TS 4-18 07294(R) MODIFICATION OF ENGINE CONTROL MODULE

1992 Suzuki Swift

TECHNICAL SERVICE BULLETIN

MODIFICATION OF THE ENGINE CONTROL MODULE (ECM)

Fig. 1: ECM Name Plate Location

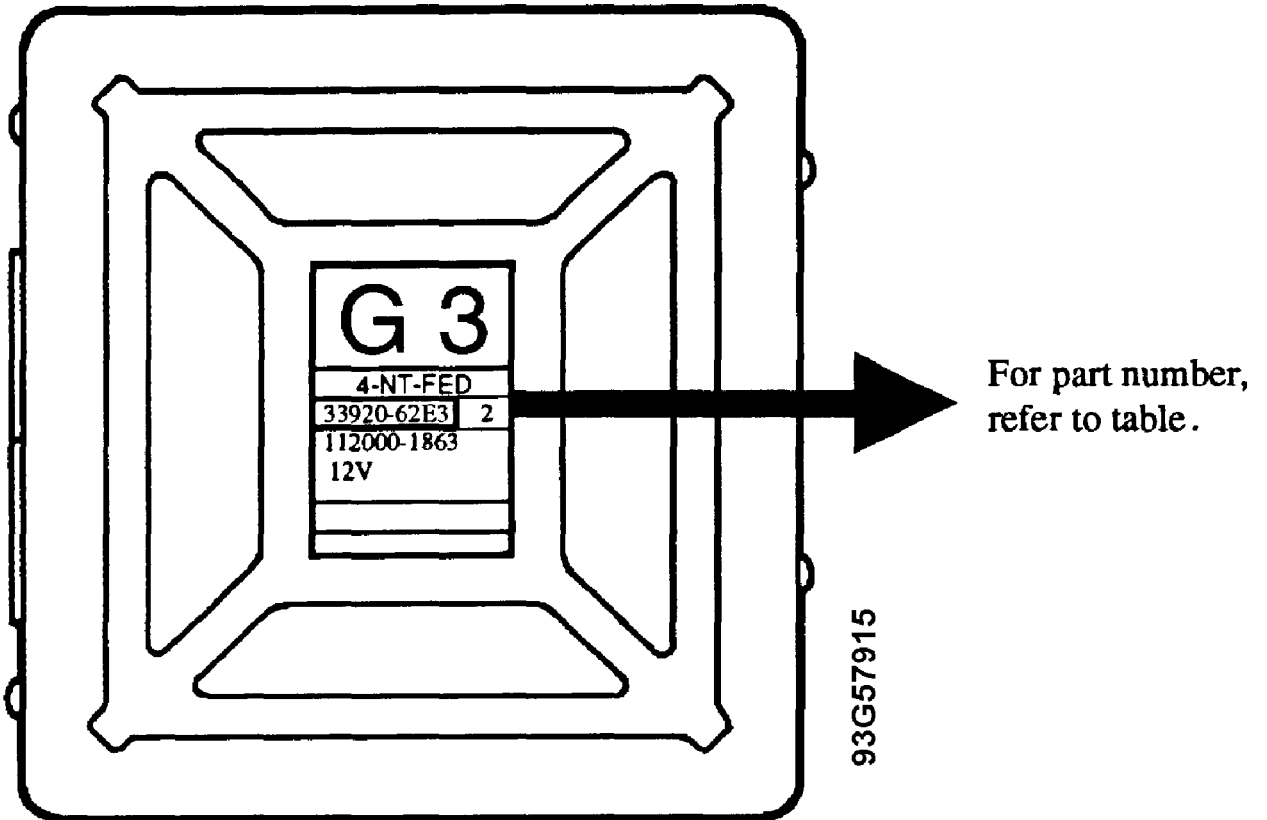
Refer to the ECM name plate part number given in the list below. This method is also applicable to the M/T vehicle whose emission control label is illegible. Refer to Fig. 1 for the ECM name plate location.
